Re: C15-2020-0019

Austin Energy (AE) has reviewed your application for the above referenced property, requesting that the Board of Adjustment consider a variance(s) from the following section of the Land Development Code; Section 25-2-899 (E) (*Fences as Accessory Uses*); To increase the height permitted from 6 feet (required) to 8 feet (requested);

BOA GENERAL REVIEW COVERSHEET**CASE:** C15-2020-0019**BOA DATE:** April 13, 2020**ADDRESS:** 2604 E. 6th St**COUNCIL DISTRICT:** 3**OWNER:** Darryl Dadon**AGENT:** N/A**ZONING:** SF-3-NP (Holly Neighborhood Plan)**LEGAL DESCRIPTION:** LOT 20 OLT 11 DIV A MORSLAND PLACE**VARIANCE REQUEST:** fence height request to 8 ft.**SUMMARY:** construct an 8 ft. fence**ISSUES:** utility pole, burglaries, and construction of a swimming pool

A1.1

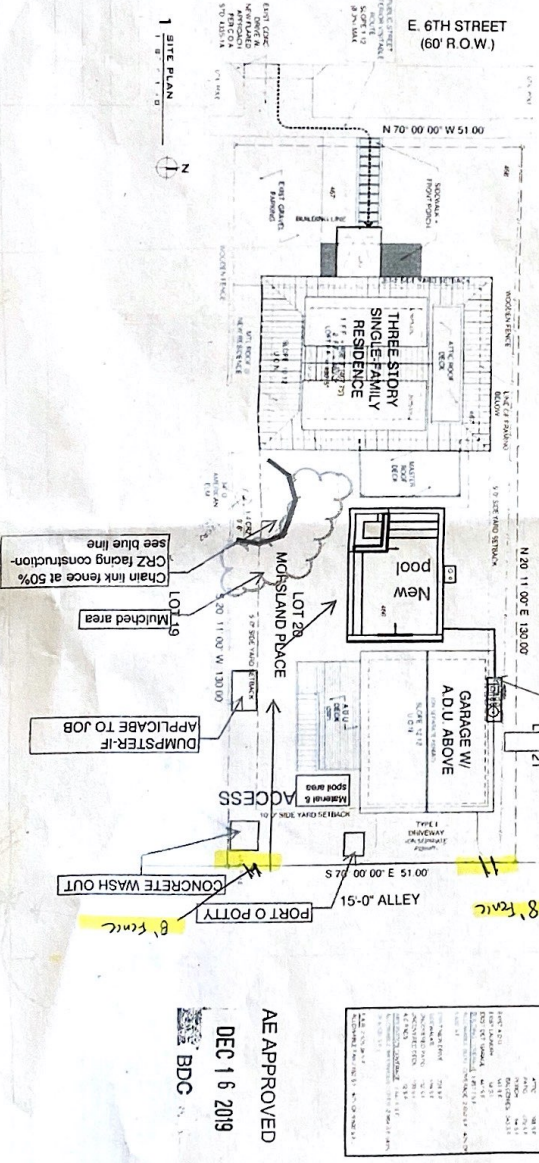
All structures/pool/etc.
 Must maintain a 10' OH
 Horizontal clearance from
 AE energized power lines
